Report to Committee

RZ 14-678448

Re:

Revised Rezoning Considerations for the Application by 1004732 B.C. Ltd. for Rezoning at 6840 & 6860 No. 3 Road and 8051 Anderson Road from "Downtown

Attachment E: Revised Survey Plan (SRW)

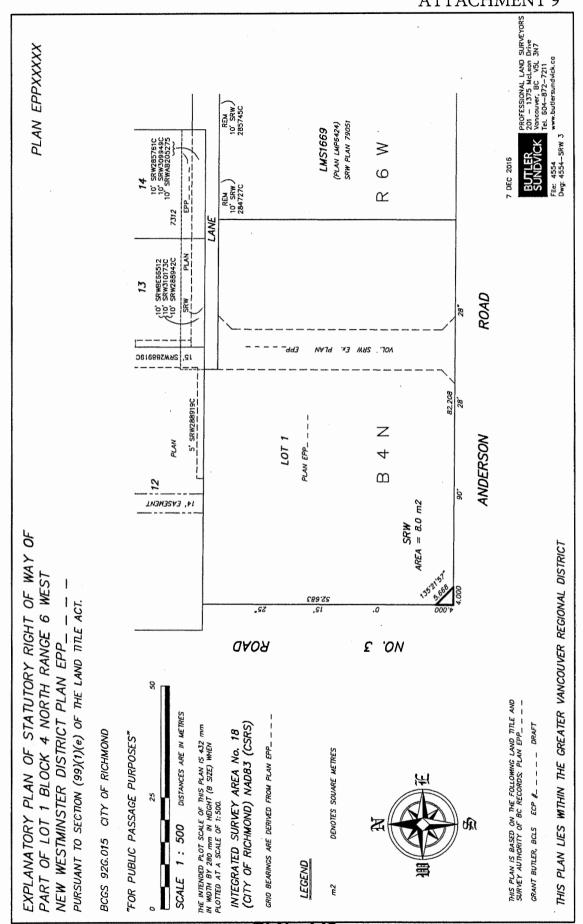
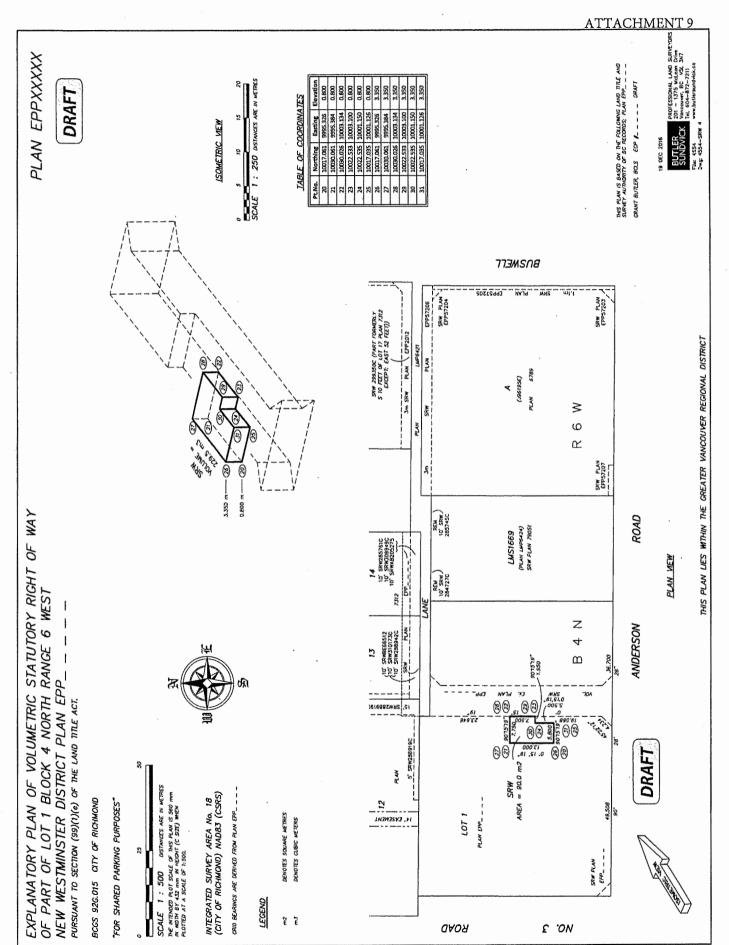
As the property owners to the north were unwilling to provide the SRWs, the applicant has made minor modifications to the design to provide for access and egress using Anderson Road only, through the provision of a turnaround area on-site. The revised plans are provided in Attachment C, with clouding showing the proposed changes. A red-lined version of the proposed revised rezoning considerations is provided in Attachment D, which removes the off-site SRW requirement (item #7 of the rezoning considerations) and modifies additional considerations consequential to this change as described below.

The turnaround area is proposed to be located in the northeast corner of the site, and requires that a portion of the building on the ground, mezzanine and second floors be recessed to provide adequate vehicle maneuvering area and clearance. The original rezoning considerations included a requirement for a volumetric public right of passage (PROP) and SRW to secure the north-south lane for access (item #4). This consideration has been revised to include the new area for vehicle turnaround. The applicant has provided a revised preliminary SRW PROP plan to demonstrate this change (Attachment E). The final plan will be confirmed and secured through the Servicing Agreement process, along with the following additional works (item #29):

generally as shown in the related sketch survey plan (RTC Attachment 9E) and subject to final dimensions established by the surveyor on the basis of functional plans completed to the satisfaction of the Director of Transportation, providing for:
